## **CHEYENNE VAMC MRI SITE PREP**

Project # 442-DSI-400

**DATE: November 13, 2015**

### **ADDENDUM NO. 3**

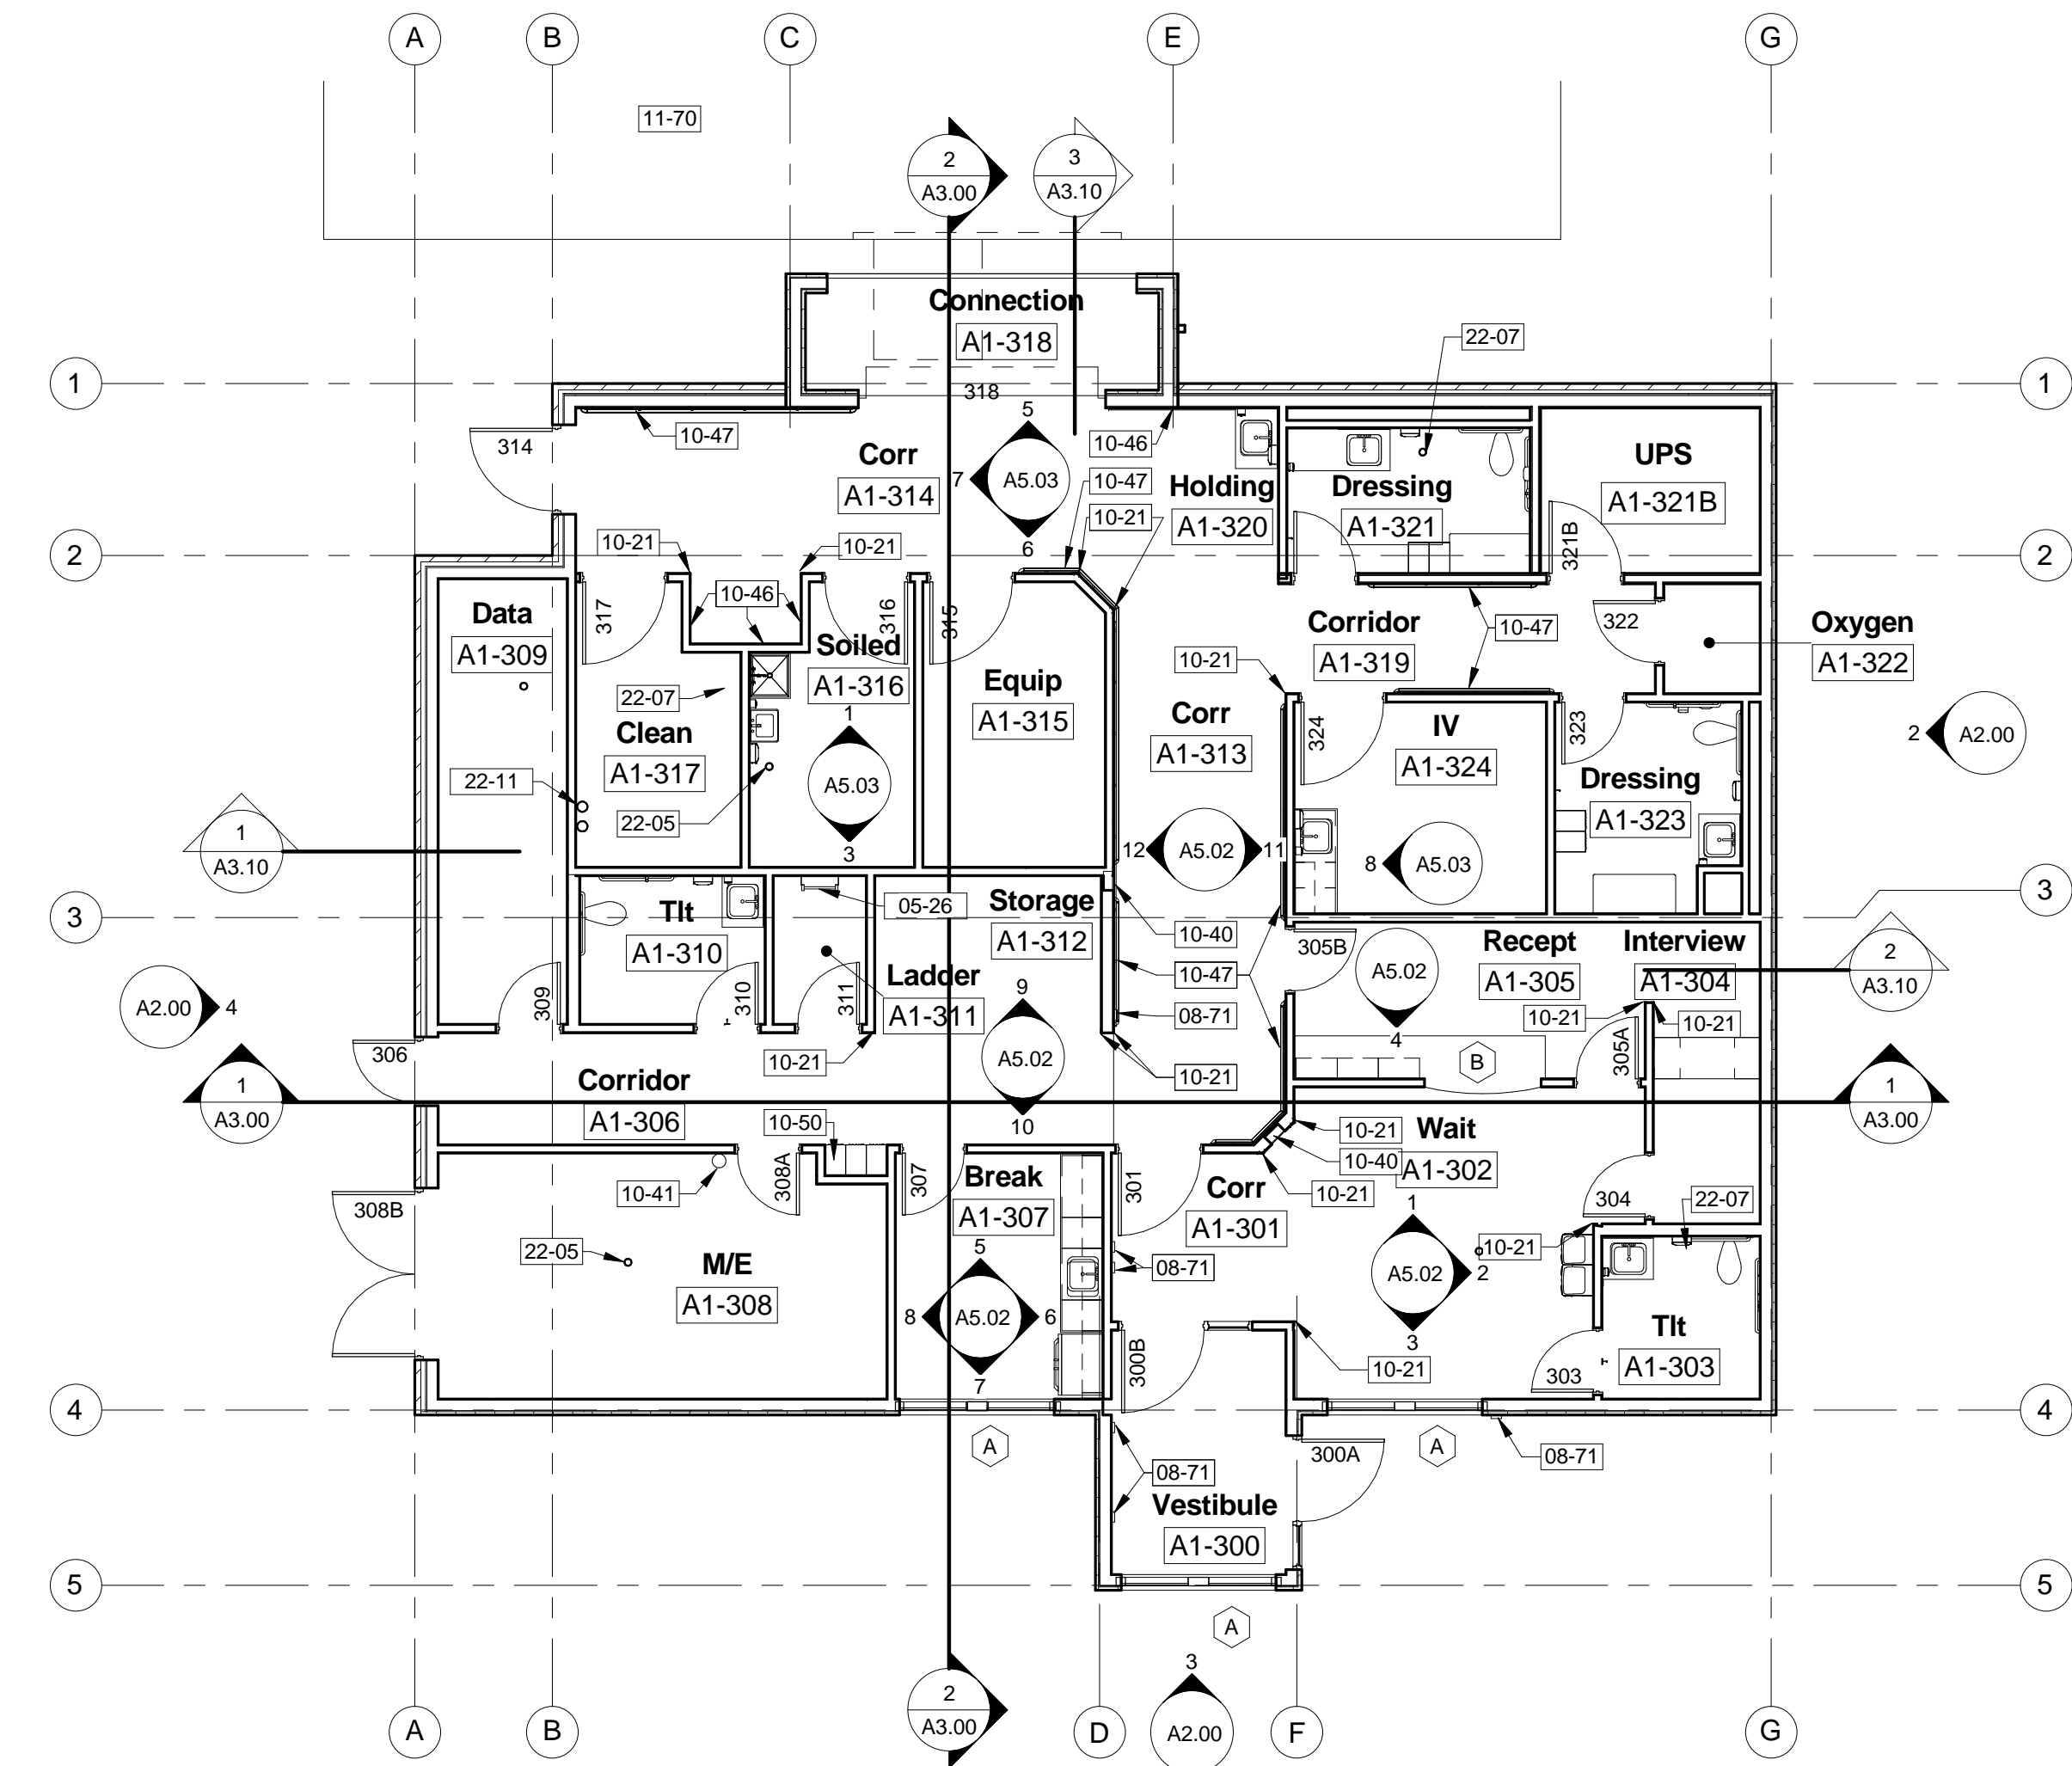
- Add horizontal 3000 cfm 8-1/2 Ton packaged electric cooling rooftop unit with hot water heating coil, economizer and barometric relief damper on the roof. The unit will sit 14'5" from East Wall and 5' from North Wall. 22" X 22" (internal dimension) exterior ductwork with 4" insulation and UV compatible PVC or aluminum jacket will run exposed and serve the UPS room through one (1) high double deflection supply grille and one (1) low louvered return grille.

- 500 CFM 1/20 HP upblast exhaust fan with extended curb will be mounted on the roof in the center of UPS A1-321B. Ductwork shall include motorized damper with 2" drip pan and will terminate as close as possible to the roof deck allowing enough room for the motorized damper. Provide insect screen all round and 2" water tight pan 2" larger than drop mounted 12" below exhaust duct.
- Provide 24" X 24" extruded aluminum louver with drainable blades, equivalent to Greenheck model ESD-365, on the east wall with insulated thermally broken motorized damper, insulated sheet metal plenum, and differential static pressure sensors.

Motorized damper on wall louver shall open when a pressure differential between the UPS room and the corridor exceeds  $-0.02''$  SP (Adjustable).
